OFFICIAL RECALL NOTIFICATION U.S. FEDERAL BOAT SAFETY ACT - SHIFT LINK BAR CONTACT WITH THE BACK COVER OF BRAVO X / XR DRIVES

Model	Serial Number Range
Bravo X I / II / III Drives	0W250000 through 0W266345
Bravo XR I / III Drives	0W240000 through 0W240652

New cover with added link bar clearance

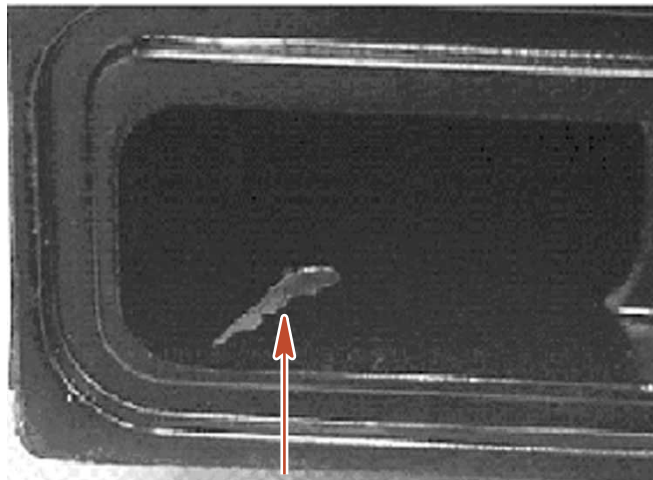
The shift link bar at the shift lever is making contact with the back cover of the drive shaft housing. The contact may cause the cotter pin to wear through, allowing the link bar to become disengaged from the shift lever, resulting in loss of shifting control. In right-hand rotation models it is also possible that the cone clutch could be prevented from engaging properly into the gear socket, resulting in the cone clutch being stuck in gear.

Contact area from link bar

a - Area of indentation marks on the link bar washer **b** - Wear area on the link bar cotter pin

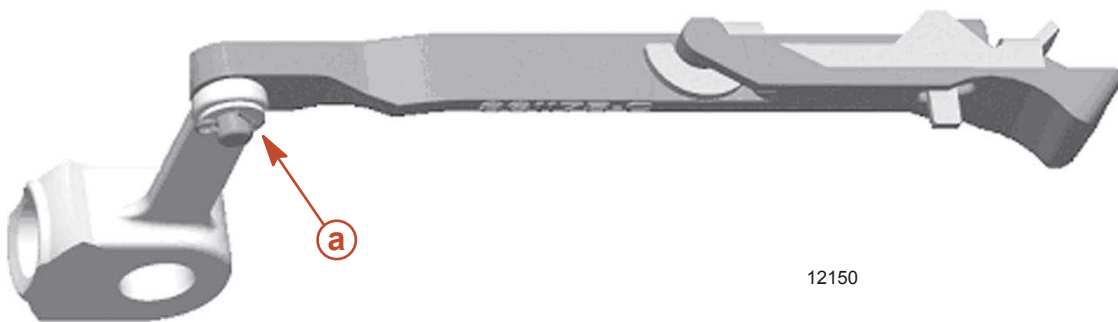
If the drive unit has been operated 30 hours or more, inspect the washer on the link bar for indentation marks from the cotter pin. If there are indentation marks on the washer, change both the washer and the cotter pin before installing the new rear cover.

1. Remove the back cover of the drive unit. Examine the shift link bar and cotter pin area, as well as the inside of the cover. The washer and cotter pin must also be inspected for any indentation marks on the washer from the cotter pin caused by heavy contact.
2. Replace the washer and/or cotter pin if there are indentation marks on either, then install the new back cover and seal from the replacement back cover kit. Using Special Lubricant 101, lightly grease the new detent ball canister and spring assembly and place it into the new back cover before installation.
